## Appendix S10 - Airport Business Zone Structure Plan

CONSULTATION PERIOD: 2021-2022  
 PREPARED BY: WAIIPA DISTRICT COUNCIL  
 DATE: 2022-06-22

**Airport Business Zone Structure Plan**  
Appendix S10

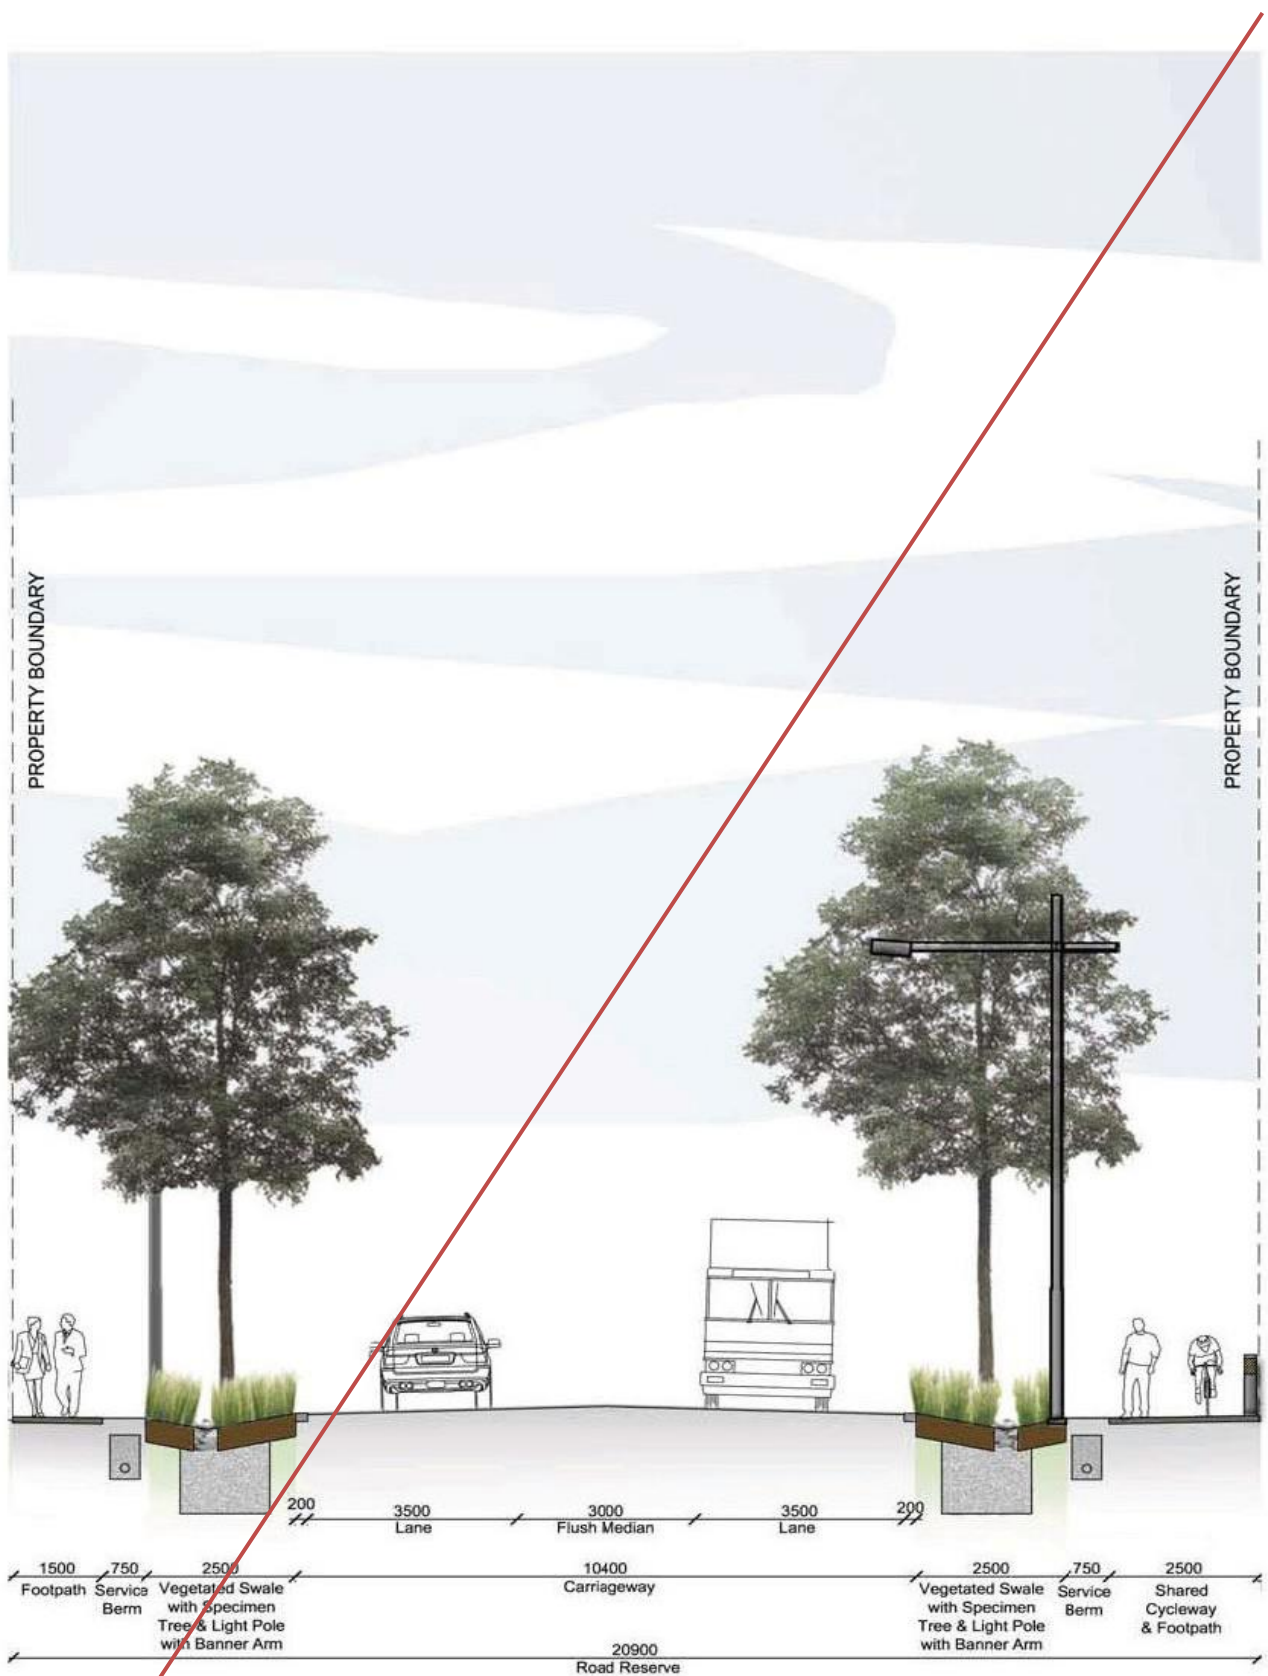
- S10.2.1 A ~~40ha~~ ~~130ha~~ [PPC20] area of land to the northwest of the airport adjacent to the main runway known as the Northern Precinct has been identified for expansion of the business park. ~~A master planning approach has also been applied to this land so the principles in S10.3 (where relevant) will apply to it.~~ [PPC20]

- S10.2.2 There will be no vehicle access from ~~lots or activities within~~ the Northern Precinct land to Narrows Road, ~~Raynes Road,~~ or ~~any section of~~ Middle Road ~~that does not have Airport Business zoned land on both sides, and vehicle access will be by way of an internal road connection to the Western Precinct.~~ [PPC20]

- ~~S10.2.3 Access will be achieved through intersections onto State Highway 3 (SH3) and Raynes Road while protecting the ability to establish a direct connection to the future Southern Links Central interchange when it is constructed.~~ [PPC20]

- ~~S10.2.4 Several transport upgrades will be required to enable the full development of the Northern Precinct. These upgrades, along with when they will be required, are set out within Rule 10.4.2.13A within Section 10.~~ [PPC20]

- ~~S10.2.5 Development of the Northern Precinct will occur in a way that protects identified Bat Habitat Areas and maintains or enhances long-tailed bat habitat values.~~ [PPC20]

- S10.2.6.3.2 Development of the Northern Precinct land is ~~also~~ subject to ~~approval of a Comprehensive Development Plan in accordance with~~ [PPC20] the rules in Section 10 – Airport Business Zone (Titanium Park) and Section 15 – Infrastructure, Hazards, Development and Subdivision.
